Value Engineering Study
WWTP #2 Improvements
Coos Bay, OR

FINAL VALUE ENGINEERING STUDY REPORT

WWTP #2 IMPROVEMENTS

Coos Bay, OR

Baseline Sketch 1

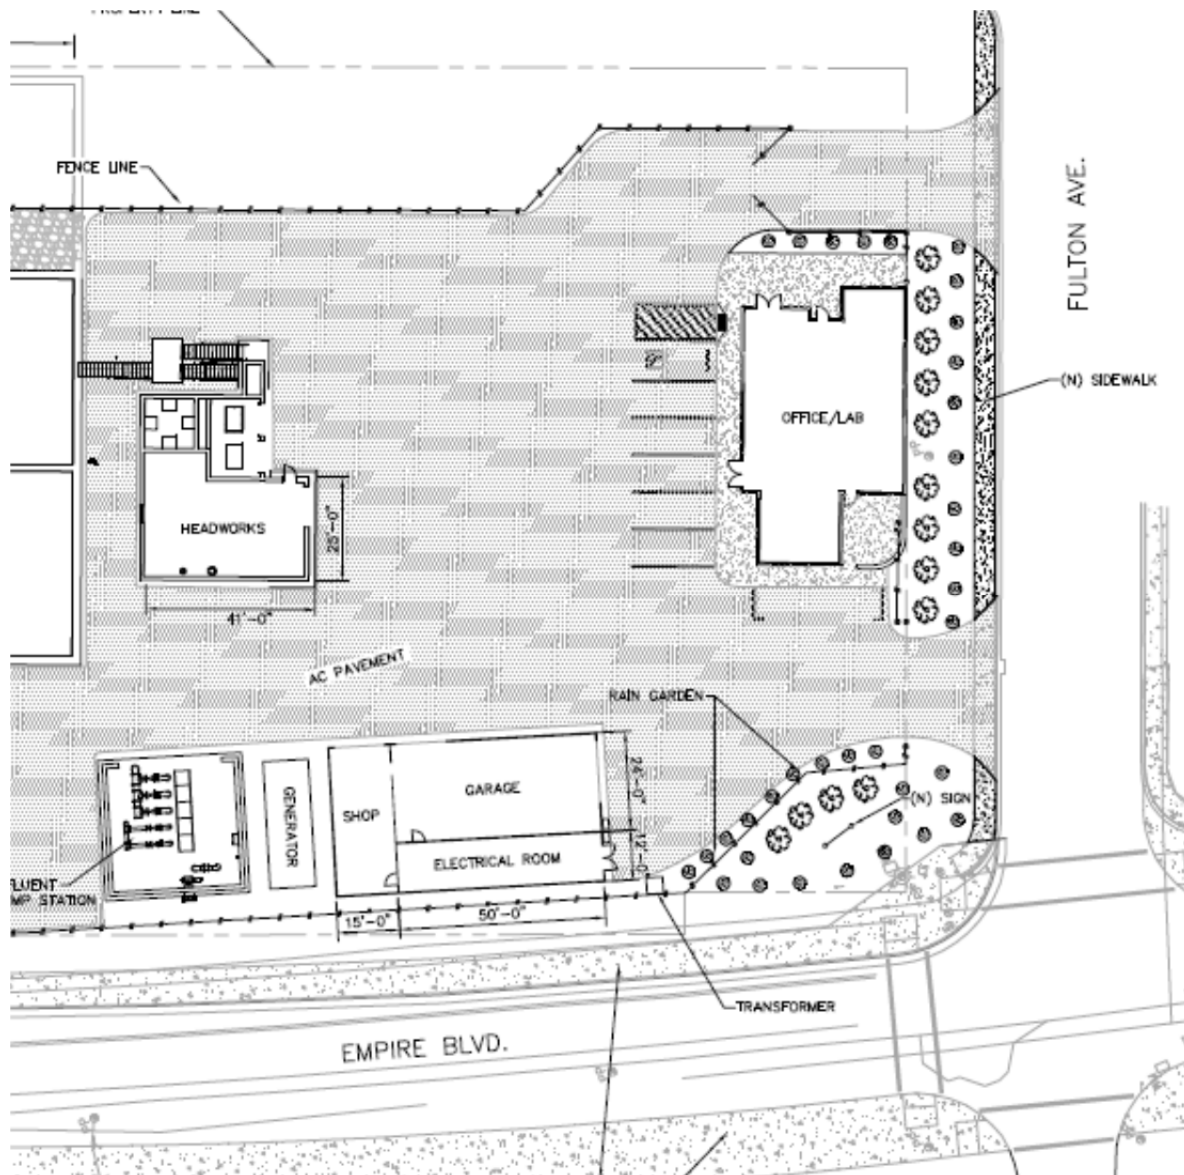
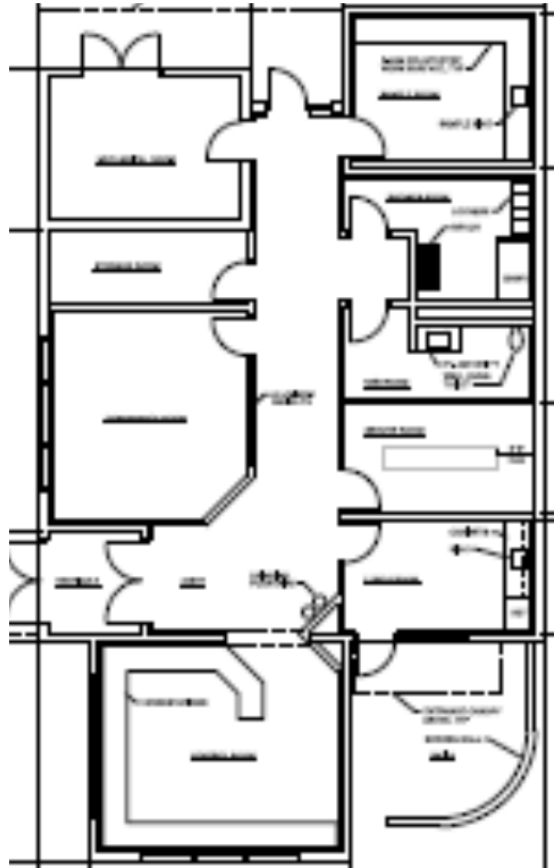
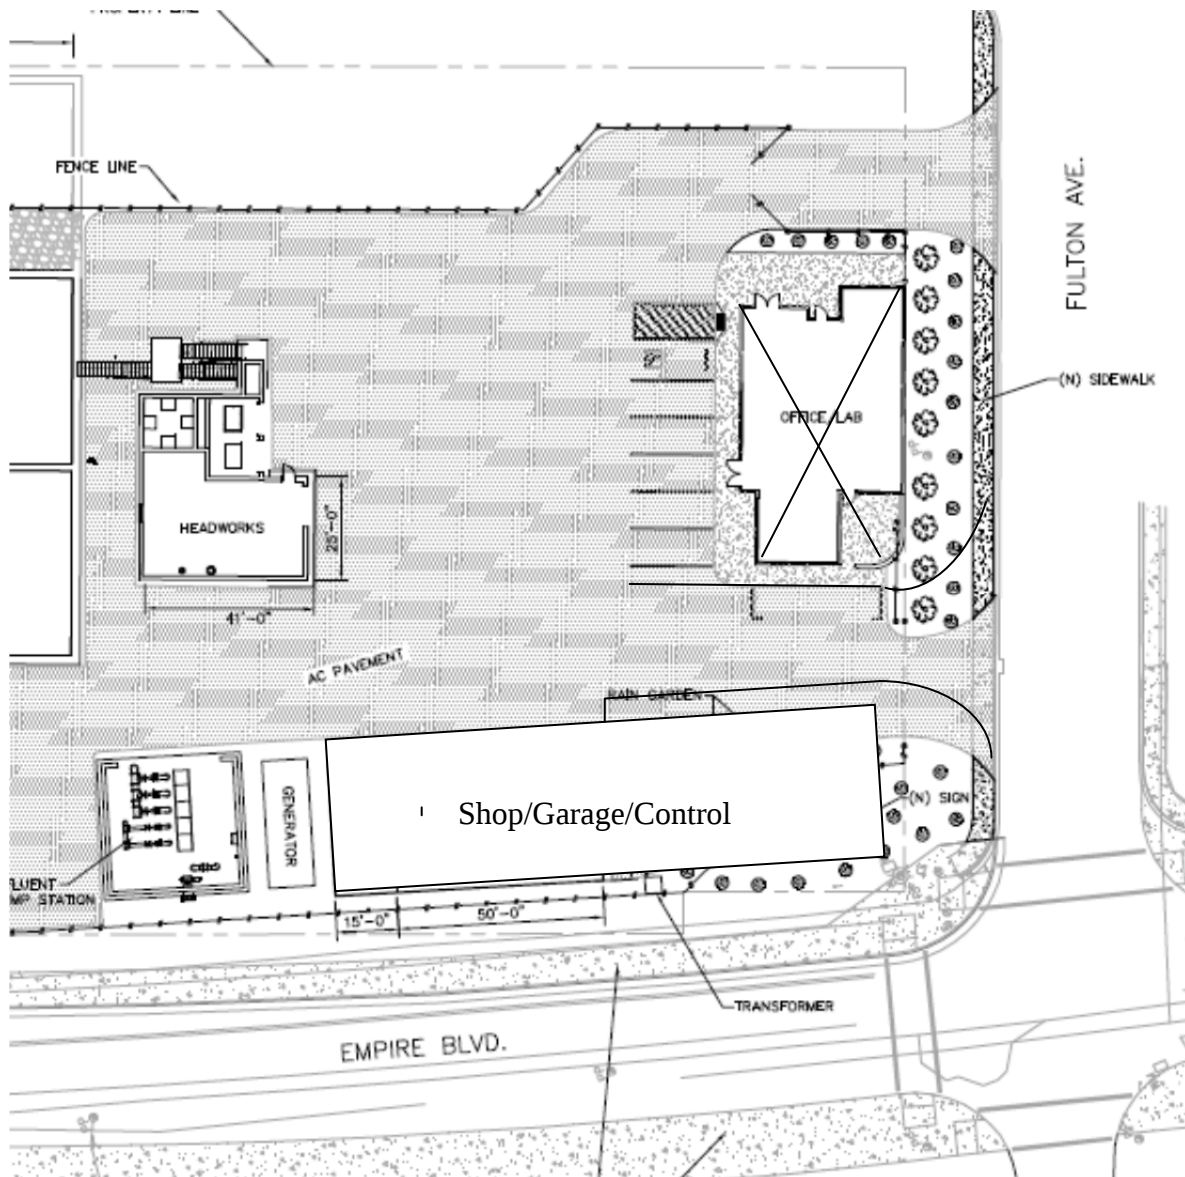
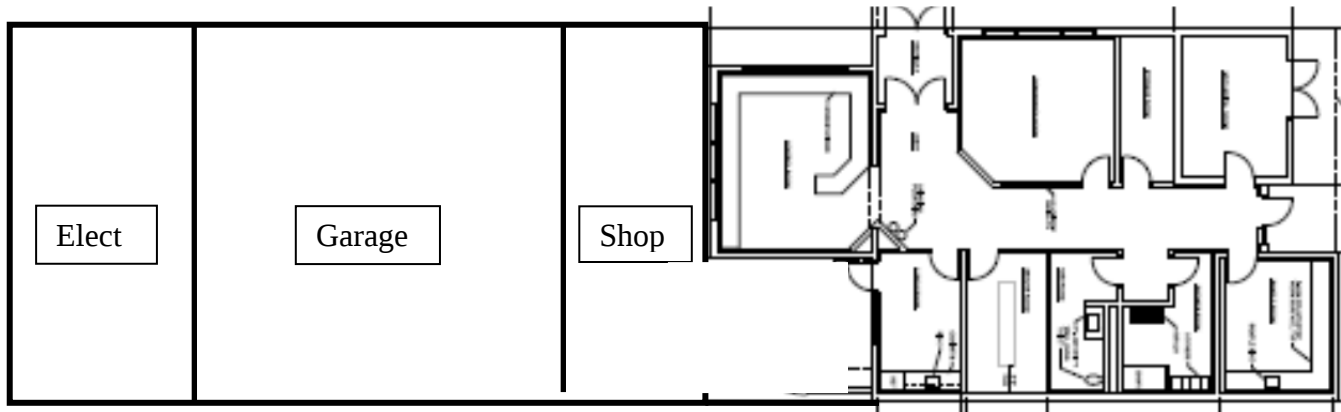
The existing concept has separated non-process functions into two buildings. The relatively clean spaces are located in the Control Building and relatively dirty spaces are located in the Garage/Shop Building. The main Electrical Room for the plant is located in the Shop/ Garage Building to be closer to the high-load process equipment. The buildings are designed fit into the architectural theme where exterior treatments are “uniform and complimentary across all structures on site”. The current architectural theme is utilizing 12” thick cast in place concrete (CIP) for the primary exterior wall material. The control building is located along Fulton Ave. along with two vehicles. The Shop/Garage is located along the Empire Blvd side of the site. Both are located near the property line and are sited to help screen the process areas of the site from public view.

The proposed idea is to consolidate the two buildings into a single structure that parallels Empire Blvd. All of the programmed spaces would remain at the same size. The control building spaces would be located near the southwest corner of the site. The parking stalls could be located where the current Control Bldg is sited. The electrical room could be located on the north end of the building, near the generator and process equipment. The shop could be located near the other staff support spaces.

Baseline Sketch

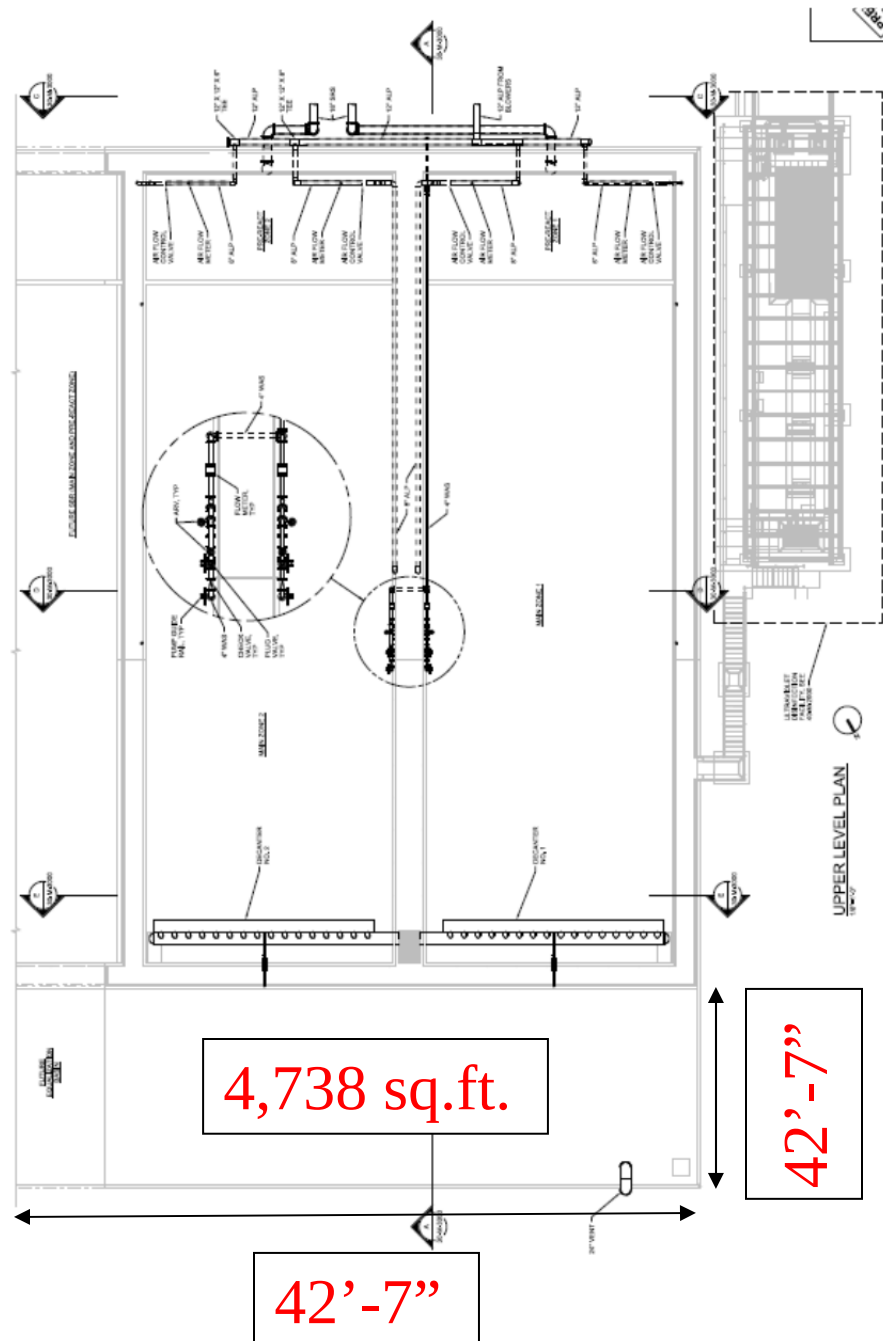
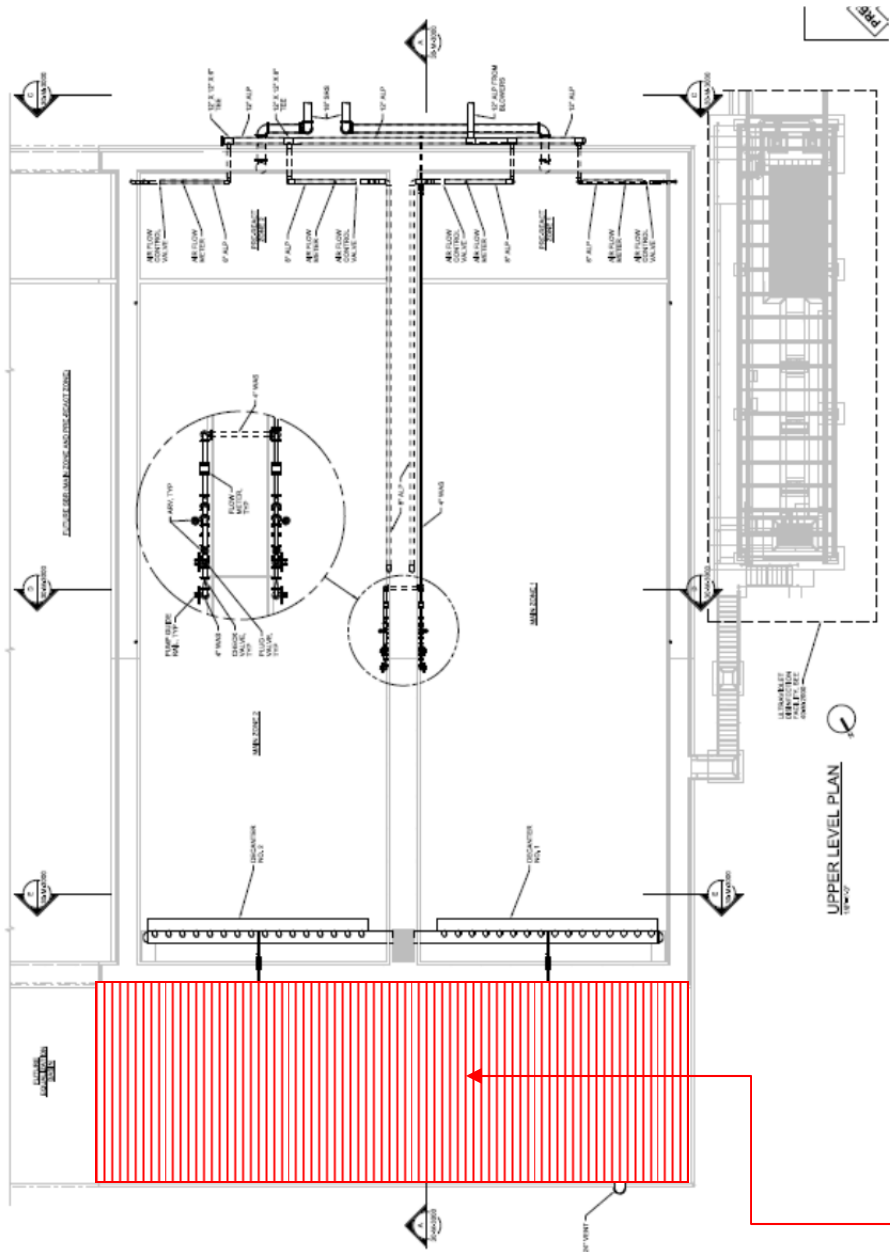
The baseline concept is to provide a concrete roof slab for the suspended roof slab over the Equalization Basin. The suspended concrete slab is intended to prevent sunlight exposure to the secondary effluent stored in the equalization basin and regrowth of biological matter.

The alternative concept is to replace the concrete roof slab on the equalization basin with a metal roof. There is currently no identified function for the top of the equalization basin. The concrete cover on the the equalization basin would be designed to support roof dead load, roof live loads of 20 psf, roof snow load of 25 psf (minimum), possibly floor live loads of 200 psf for process areas (including roofs of basins), wind loads, and seismic loads. While not shown on the Preliminary Drawings the 30'-0" to 42'-7" span for the concrete cover to support the dead and live loads may require additional columns or beams.

While the VE team alternative concept was based around replacement of the concrete roof slab with a metal roof it is unlikely that a metal roof would provide an equivalent life span as a concrete roof slab without adequate corrosion protection of the metal including either galvanizing, epoxy, or some type of floor polymer coating system. There are also several proprietary systems (Temcor (aluminum) or Enduro Composites (fiberglass)) for aluminum and fiberglass type covers including secondary framing that could cost effectively be utilized to provide a UV or sunlight barrier for the equalization basin and satisfy the roof live and snow load requirements.

The equalization basin is defined as 36'-0" x 100'-0" in the Preliminary Design Report; however, on the Contract Drawing Sheet 06-C-2000 the equalization basin is defined as 42'-7" x 100'-0". This discrepancy should be resolved for cost estimate purposes.

Baseline Sketch

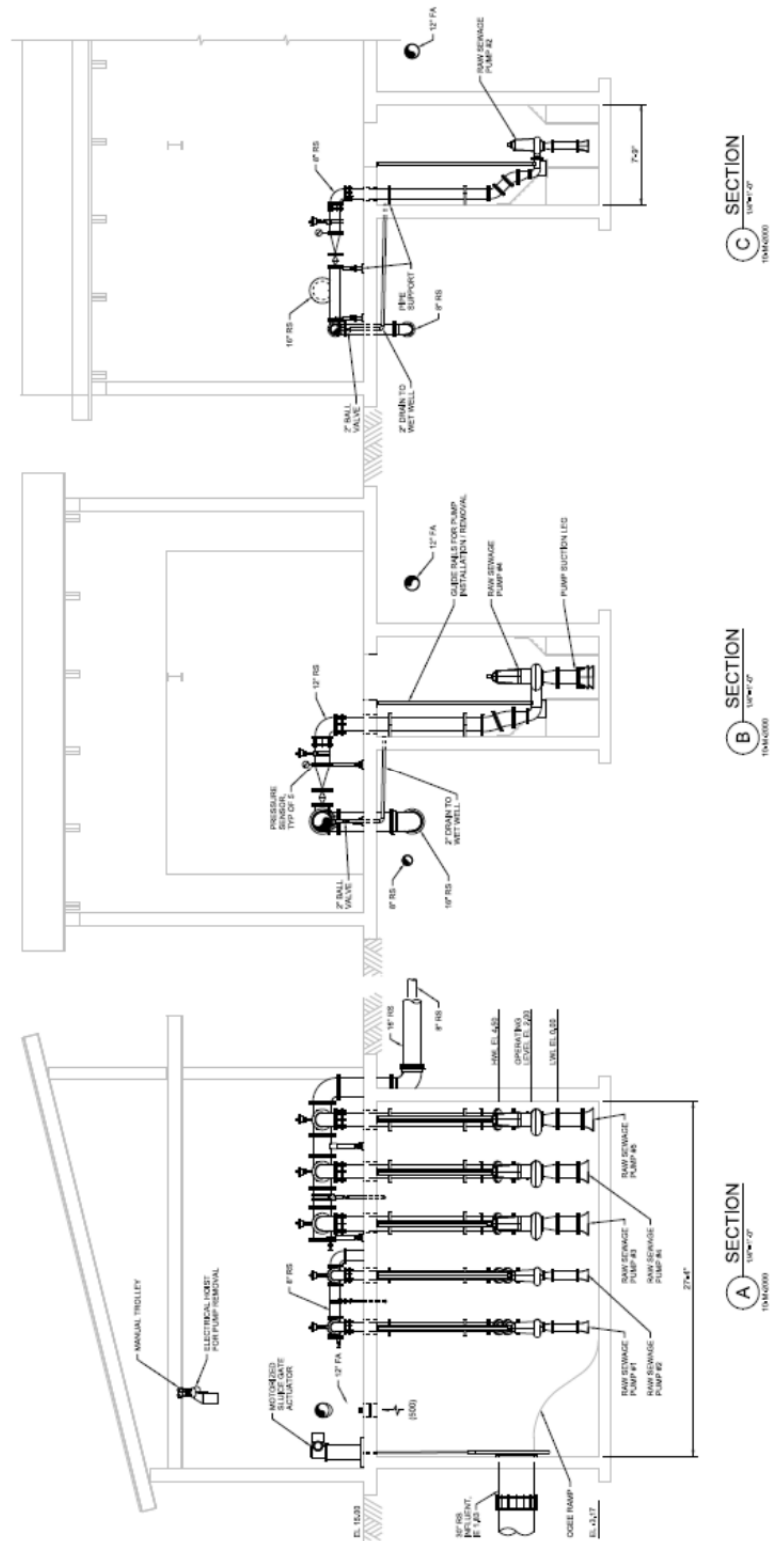
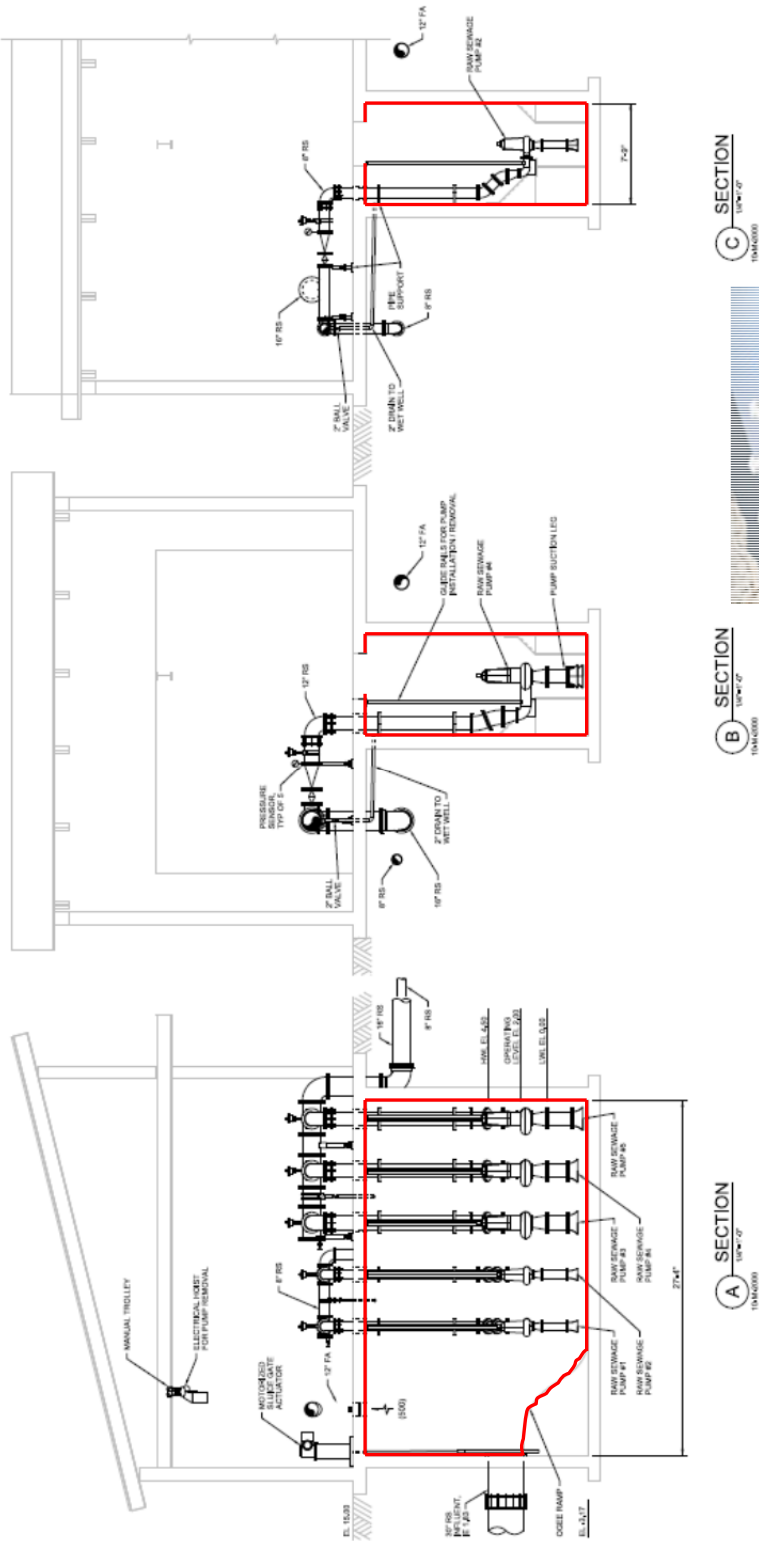
The baseline concept is to provide an Influent Pump Station with reinforced concrete wet well below grade.

The alternative concept is to provide a PVC type or epoxy coated interior protective coating system on the interior reinforced concrete surfaces of the influent pump station wet well in order to extend the life of the structure.
